**HIMACHAL ROAD TRANSPORT CORPORATION RAMPUR**  
NO:-HRTC/RMP/3- (B.S Nankhari )/2023 **3351**

**Subject: - Diversion of 0.3534 Ha. of forest land for construction of RTC Bus Stand  
at Nankhari within the jurisdiction of Rampur Forest Division, Rampur  
Bsr.**

This is with reference to the subject cited above. In this context this is to inform you that the EDS raised by the Forest Department has been attended and para wise reply for the same is as under:-

**Project Name:- Construction of Bus Stand at Nankhari tehsil rampur Distt. Shimla H.P.**

# LAY-OUT- PLAN

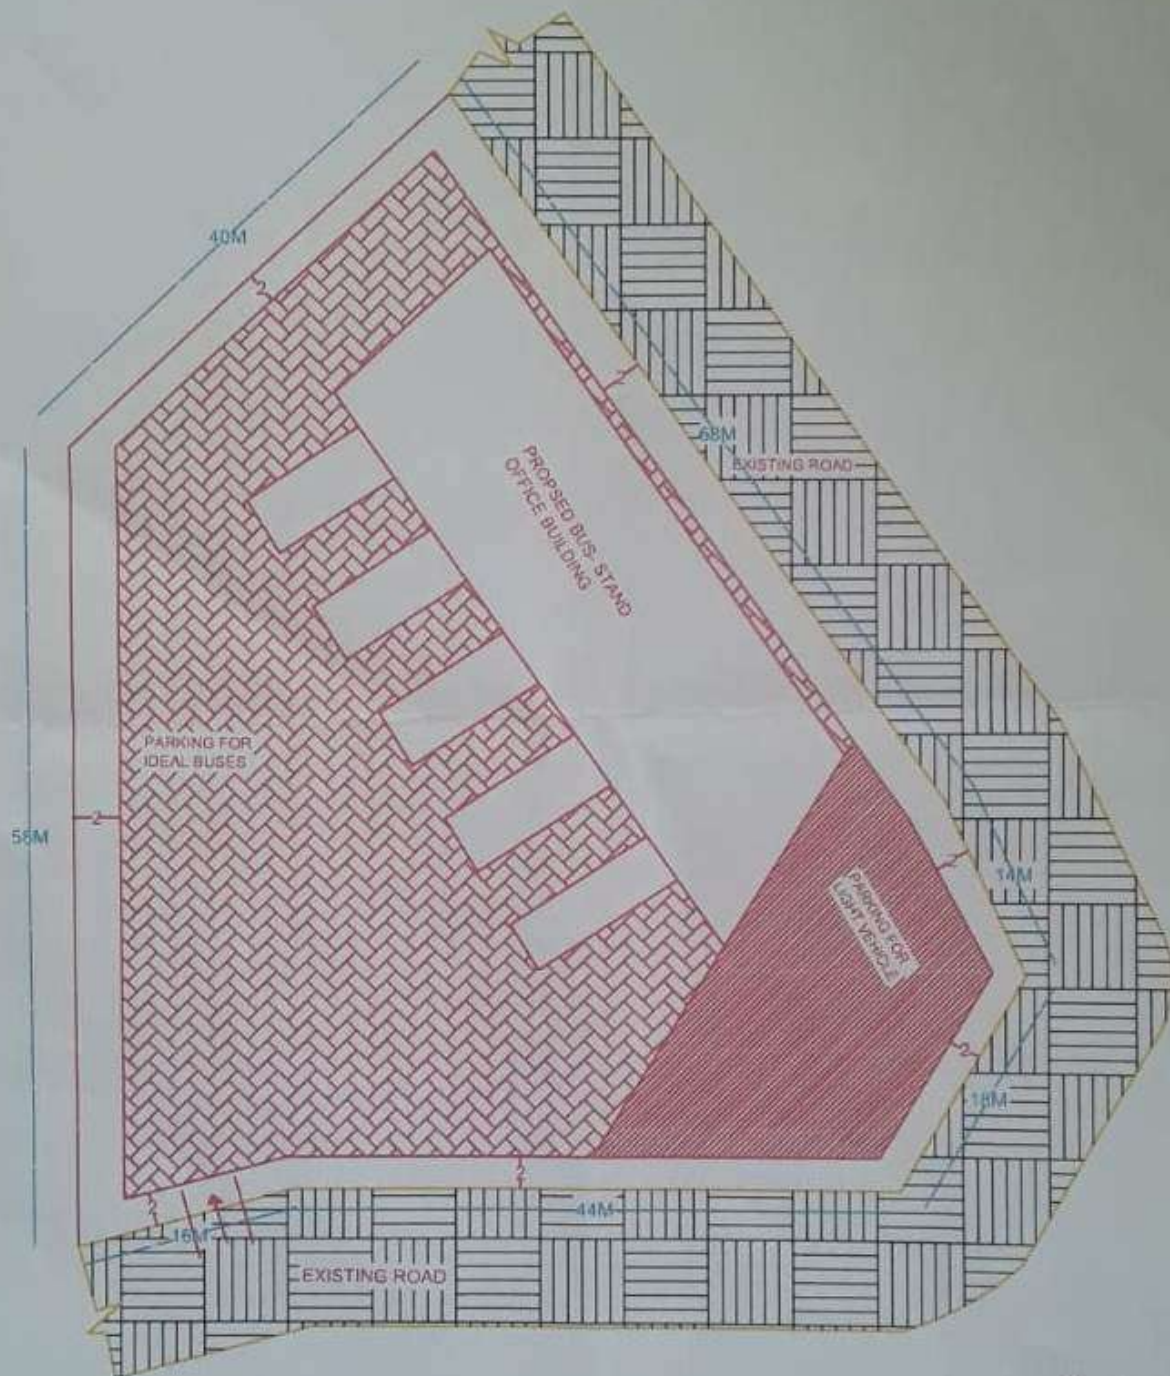
| 5 | In the online Part-I at Sr. No. B 2.4 (Component wise requirement of forest land) and other concerned documents the forest land is required for only one component i.e., construction of bus stand. After going through the layout plan of the proposal at Sr. No. 11 of additional documents the following components have been found mentioned:- |                                      | Revised Component Detail has been uploaded on the Portal against Column No. B-2.4 and Revised Layout Plan has been uploaded on the portal and placed in the proposal folders |
|   | Further, all other documents of the proposal find mention requirement of 0.3534 Ha. of forest land for construction of bus stand whereas, as per layout plan total requirement of forest land 0.3504 ha. This variation in requirement of forest land for construction of bus stand needs to be clarified                                          |                                      |                                                                                                                                                                              |
